Memo

To: Cranston City Plan Commission
From: Joshua Berry, AICP, Senior Planner / Administrative Officer
Date: April 1, 2021
Re: "Natick Avenue Solar" Preliminary Plan – Major Land Development

Owner: Ronald Rossi
Applicant: Natick Solar, LLC
Location: 0 Natick Ave, AP 22-3, Lot 108 & 119
Zone: A-80 (single family dwellings on lots of minimum areas of 80,000 ft²)
FLU: Single family residential less than 1 unit/acre

EQUIPMENT EXAMPLE FOR ON-SITE UNDERGROUND INTERCONNECTION

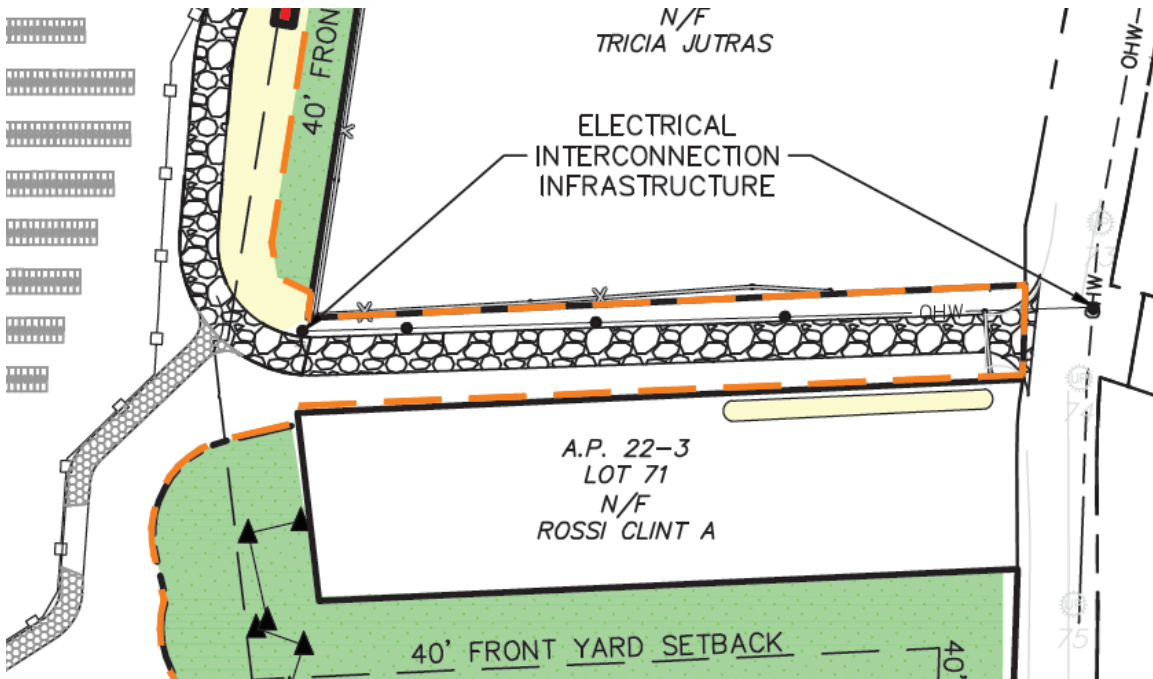
In addition to the attributes of the project that distinguish it from other sites and other on-site interconnection plans, staff has learned more about what undergrounding the on-site utilities entails and is not convinced that it would necessarily result in a preferred outcome for this project. National Grid designers assigned to this project explained that one of the five on-site poles, the one closest to Natick Avenue, would be required even if the utility lines were undergrounded, and that 3-4 equipment pads would need to be located along the project access road. Adding to the aesthetic impacts of the equipment, yellow bollards are required to prevent vehicle collisions. The National Grid representatives conveyed that the underground conduits would need to be 5'-6' deep, resulting in more ground disturbance in this area (possibly including blasting) than would be required to install poles.

During the March 2nd meeting, staff raised the question whether there would be sufficient space for the equipment considering the setbacks. There is a 10' minimum (25' preferred) setback for the equipment to property lines and any objects (for cooling/ventilation purposes), and a 6' setback for the bollards from the equipment. Assuming a 6' pad, the 10' setback to property lines and 6' setback of the bollards (which are 6 inches in diameter) the equipment and bollards would take up 22.5' and would leave roughly 27.5' remaining for the access road. The property is 50' wide in that area.

The Plan Commission requested photos to assist them in better understanding this issue. Staff has verified the image below with National Grid to be a fair representation of the equipment required for an underground interconnection. This particular example is an Eversource connection, not National Grid, but has been confirmed as "maybe not exact, by very similar" to what the equipment might look like for this project. The transformer (4th piece of equipment from the left) for the Natick Ave project will be located interior to the site, but it would need to be replaced by a pad-mounted recloser.

*Although the Commission members expressed concern with the condition, it was not clear what aspects of the condition were unsatisfactory. Without direction, staff does **not** propose substantive changes to the condition, but continues to **recommend that the Commission delete this condition.***
